PREPARED FOR THE PLAN COMMISSION

Project Address: 1936-1938 Atwood Avenue (District 6 – Ald. Rummel)
Application Type: Planned Development Zoning Map Amendment, Demolition & Conditional Use
Legistar File ID # [54249](#) & [54038](#)
Prepared By: Chris Wells, Planning Division
Report Includes Comments from other City Agencies, as noted
Reviewed By: Kevin Firchow, AICP, Principal Planner

Figure 2 – Proposed Development Compared to Surrounding Context

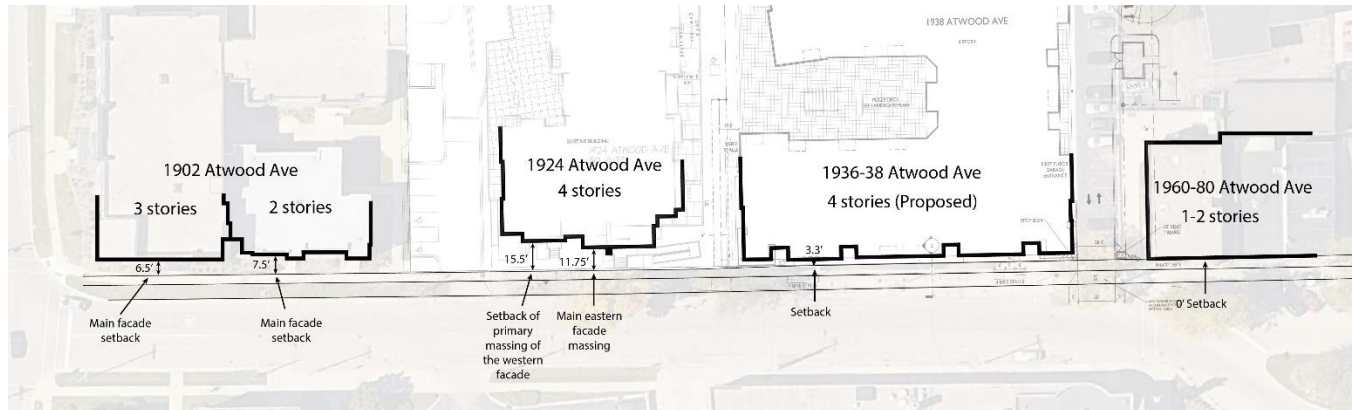
Please see the graphic below for an analysis of the building setbacks for this block of Atwood Avenue, noting that unlike the subject building which would fall under TSS (Traditional Shopping Street District) zoning, both of the buildings to the west of the subject building are zoned PD (Planned Development District). The proposed building has a street setback of over three feet compared to the smaller one and two-story structures to the east, which are built to the property line. The four-story residential structure to the west has the deepest setback in the block, while the mixed-use building at the corner, which has some ground floor commercial uses is set back three to four feet more than the proposed development.
